**Re: Order on Consent (“CSO Order”), DEC Case #CO2-20110512-25
Modification to DEC Case #CO2-20000107-8, Appendix A
VIII. Newtown Creek CSO, M. Submit Approvable Drainage Basin
Specific LTCP for Newtown Creek**

RESPONSES TO NOVEMBER 4, 2017 DEC COMMENTS ON THE NEWTOWN CREEK LTCP

Figure 1. Location of Glendale Stormwater Pump Station

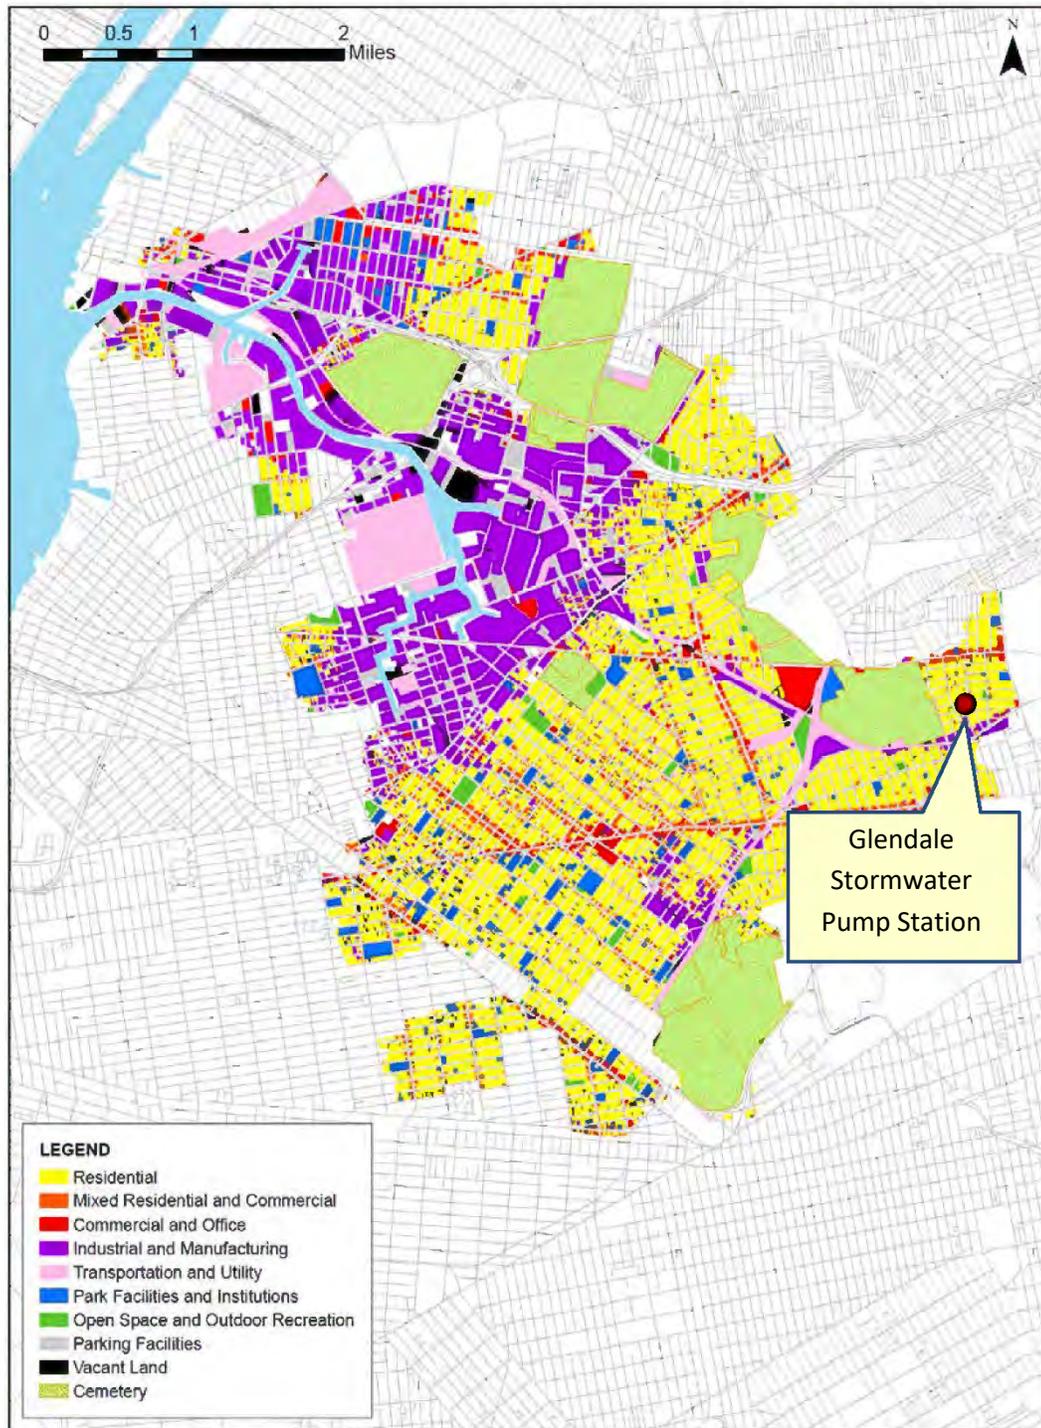
13. **Page 2-22.** The LTCP states that the Glendale PS is a stormwater station that discharges into the combined sewer system. Confirm if the DEP considered discharging the stormwater directly to the waterbody.

Response: Routing of the flow from the Glendale Pumping Station directly to Newtown Creek was initially considered as part of preliminary evaluations. However, the small contribution from this 1.2 MGD peak capacity stormwater pumping station to the combined sewer system and the approximately three miles of new force main construction required to reach Newtown Creek led to an early dismissal of this concept as a viable or cost-effective option.

Figure 1 shows the location of the Glendale Pumping Station relative to Newtown Creek. The pump station is located on Cooper Avenue west of 76th Street. No high-level storm sewers are located in the vicinity of the Glendale Pumping Station.
